Considerations related to ppm and interop (Comments #188, #432 against D2.1)

IEEE 802.3dj, Minnesota, September 2025

Comments #188 and #432

Legacy 100G/lane host (50 ppm)

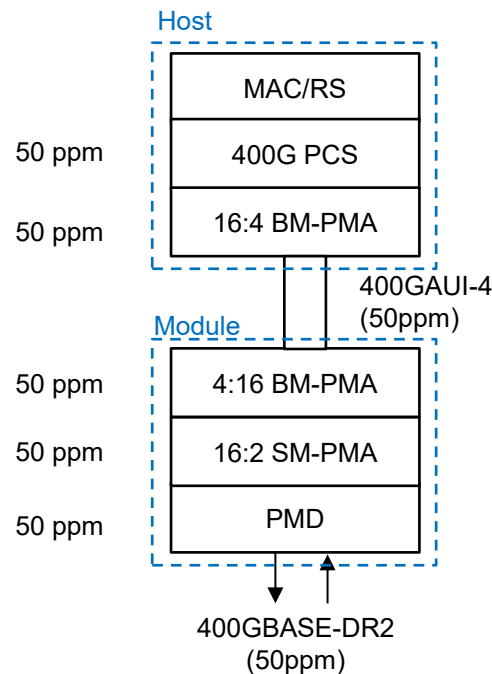
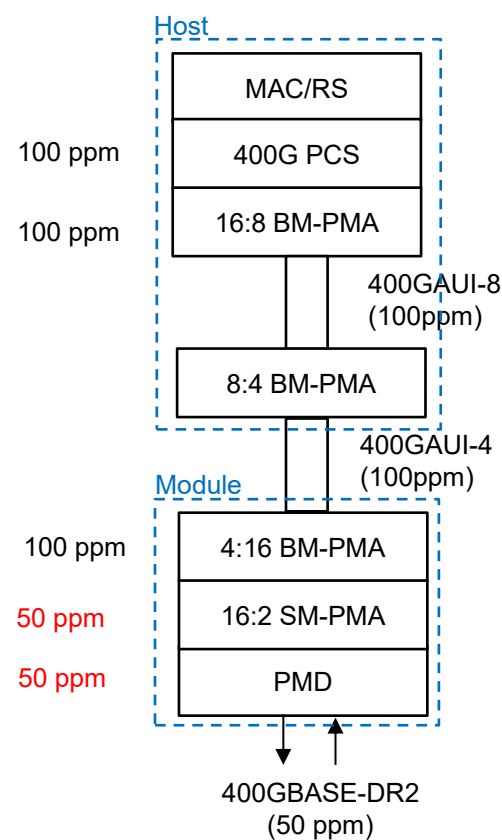
- In this case the 400GAUI-4 is co-located with PCS and required to be 50ppm (802.3ck)
- This likely accounts for the majority of 400GAUI-4 based hosts in the field
- This stack up is compliant with guideline 9) in 120.1.4, and is allowed.

Legacy 100G/lane host (100 ppm)

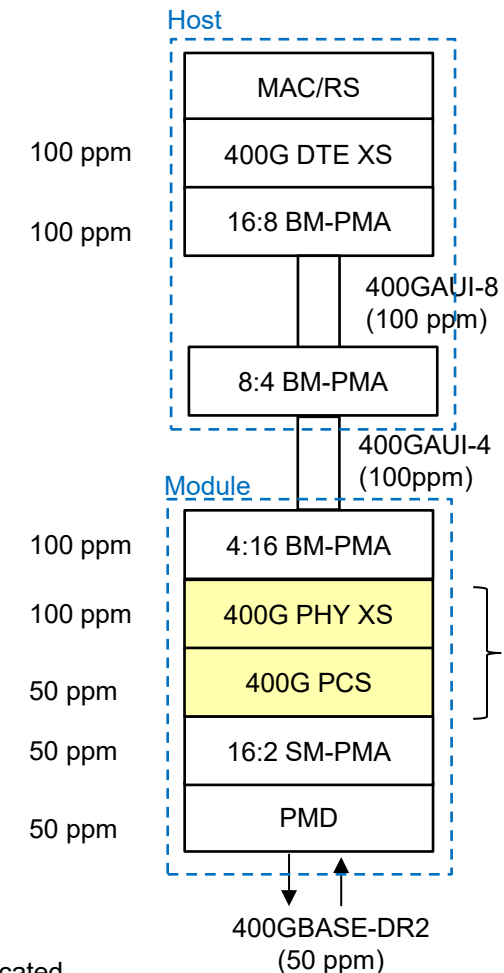
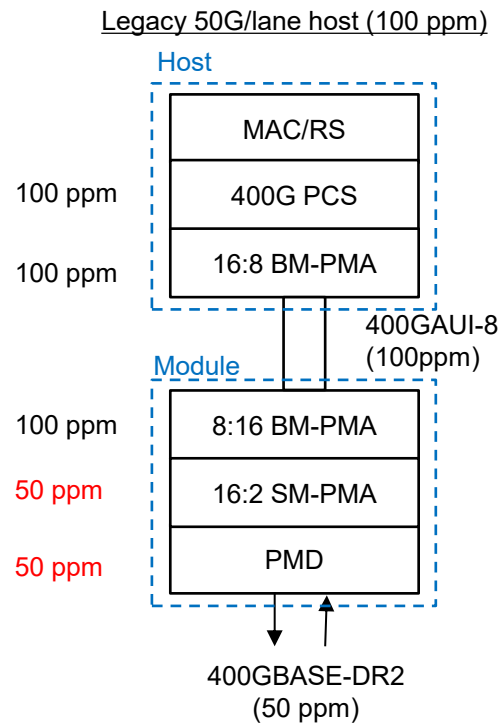
- In this case the 400GAUI-4 is not co-located with the PCS and therefore allowed to run at 100pm (802.3ck)
- This stack up is not compliant with guideline 9) in 120.1.4 and is disallowed

- Must use XS to convert from 100ppm to 50 ppm
- Requires extra functionality in module
- A different optical module is required to interface to a legacy host with a 100ppm 400GAUI-4 versus a legacy host with a 50ppm 400GAUI-4

- Update the text of guideline 7) in 120.1.4 as follows:

For a PHY that includes a 200GAUI-1 interface or a 200GBASE-KR1, 200GBASE-CR1, 200GBASE-DR1, or 200GBASE-DR1-2 PMD, the signaling rate range for a 200GAUI-8, 200GAUI-4, or 200GAUI-2 PMA output that is in the same package as the PCS shall be limited to +/- 50ppm, instead of +/- 100ppm, otherwise the 200GAUI-8, 200GAUI-4, or 200GAUI-2 shall be implemented within a 200GMII Extender.

Legacy host 50G/lane (100 ppm)

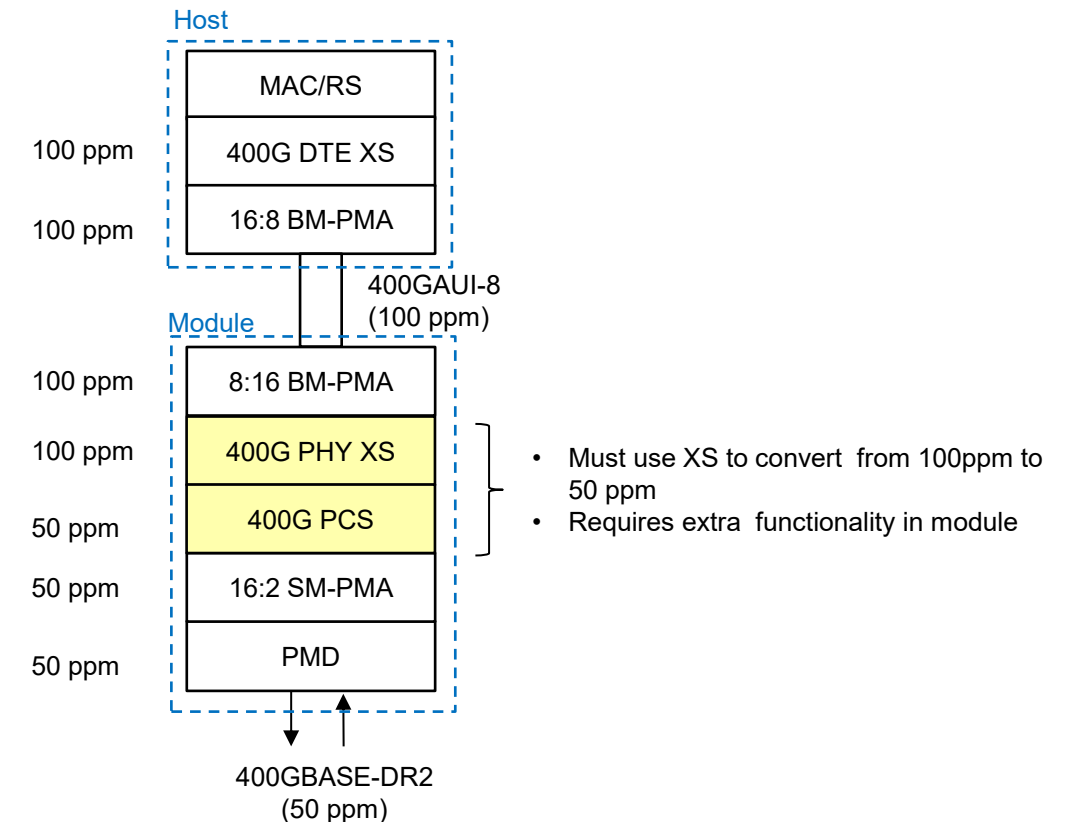
- In this case the 400GAUI-8 is always 100ppm
- This stack up is not compliant with guideline 9) in 120.1.4 and is disallowed

- In this case the 400GAUI-8 is always 100ppm
- This stack up is compliant with guideline 9) in 120.1.4 and is allowed, but requires an XS in the module
- At least this time only a single variant of module (with XS) is required

New 200G/lane host (50 ppm)

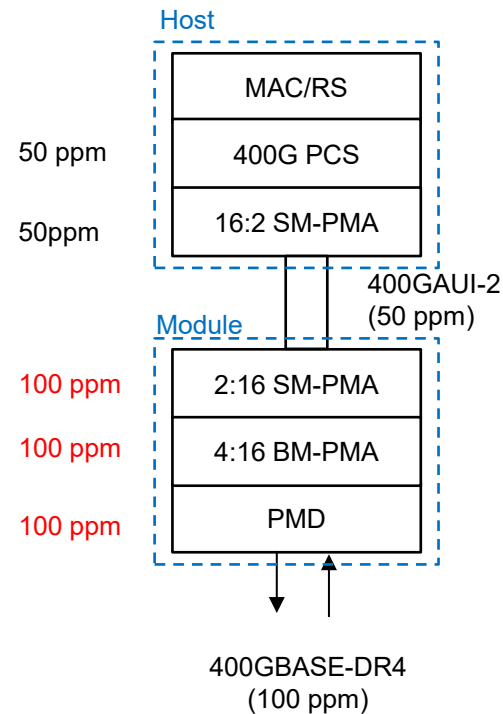
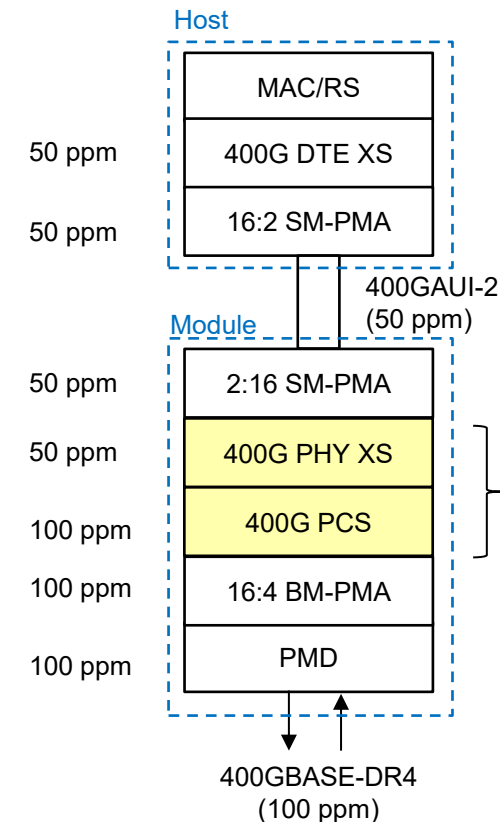
- In this case the 400GBASE-DR4 PMD has to be assumed to be 100 ppm worst case (it could be either 50ppm or 100ppm depending on far end host)
- This **stack up does not work** because of a ppm mismatch between the PMD (100ppm) and the 400GAUI-2 (only 50pm tolerant) - issue is in the receive direction only.
- Nothing in the current draft that explicitly excludes this stack up**

- In this case the 400GBASE-DR4 PMD has to be assumed to be 100 ppm worst case (it could be either 50ppm or 100ppm depending on far end host)
- This stack up is fine because ppm match is handled by the XS in the module
- This stack up is supported in the current draft
- Only a single variant of module is needed

- Needs further discussion
